TRIPLE E RECREATIONAL VEHICLES
A DIVISION OF TRIPLE E CANADA LTD.

Recall Notification CA#7420

This notice is sent to you in accordance with the requirements of the National Traffic & Motor Vehicle Safety Act. Triple E Recreational Vehicles has decided that certain 2010 Regency GT28DB & 2010 Regency GT29DB manufactured between August 2009 & February 2010 fail to conform to Federal Motor Vehicle Safety Standard No. 571.207, "Restraining device for hinged or folding seats or seat backs."

3417-EASY BED LOCK Upb. Procedure

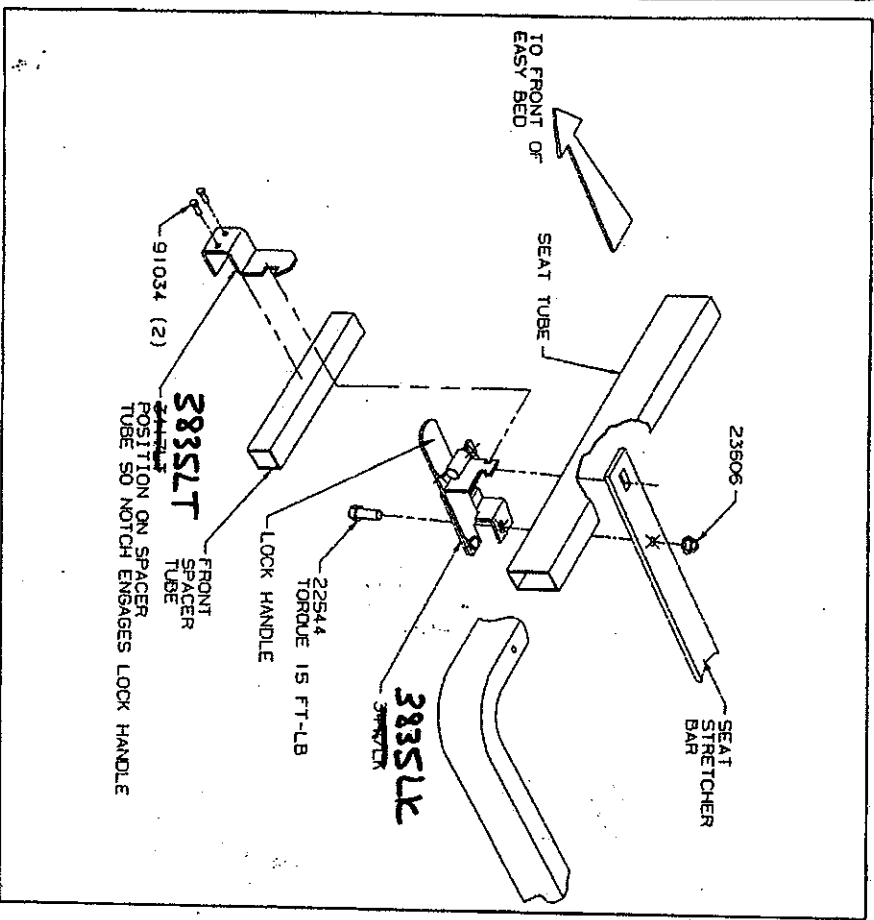
The easy-bed sofa option installed in the above mentioned motorhomes were manufactured without the roll-over safety locking latch. In the event of a motor vehicle roll over the easy-bed sofa may want to open, with the weight of a seat belted occupant, causing the occupant to be injured from the seat belt.

- OPTION 38 "L": NO LOCK ASSEMBLY
 OPTION 38 "L": LOCK ASSEMBLY
1. Insert the tab on 3417LK into the slot in the Seat Stretcher Bar. Rotate the 3417LK until the slot in 3417LK lines up with the hole in the Seat Stretcher Bar.

2. Insert a 22544-.312-18UNC-2A X .750 GRADE 5 HEX HEAD SCREW (supplied) thru the slot in 3417LK and the hole in the Seat Stretcher Bar as shown.
 3. Secure with a 23606-.312-18UNC-2B HEX FLANGE NUT (supplied) on the upper side of the Seat Stretcher Bar as shown. Torque 22544 to 15 FT-LBS.

4. With the Bed closed, position the 3417LT on the Front Spacer Tube as shown. Slide the 3417LT on the Tube until the notch engages the 3417LK lock Handle. Move the 3417LT away from the 3417LK approximately 1/16" for clearance.

5. Secure the 3417LT to the Tube with (2) 91034-#10-16 X .750 HEX WASHER HEAD SELF-DRILLING SCREW (supplied) as shown.
 6. Open and close the Bed several times to insure proper Lock Operation.
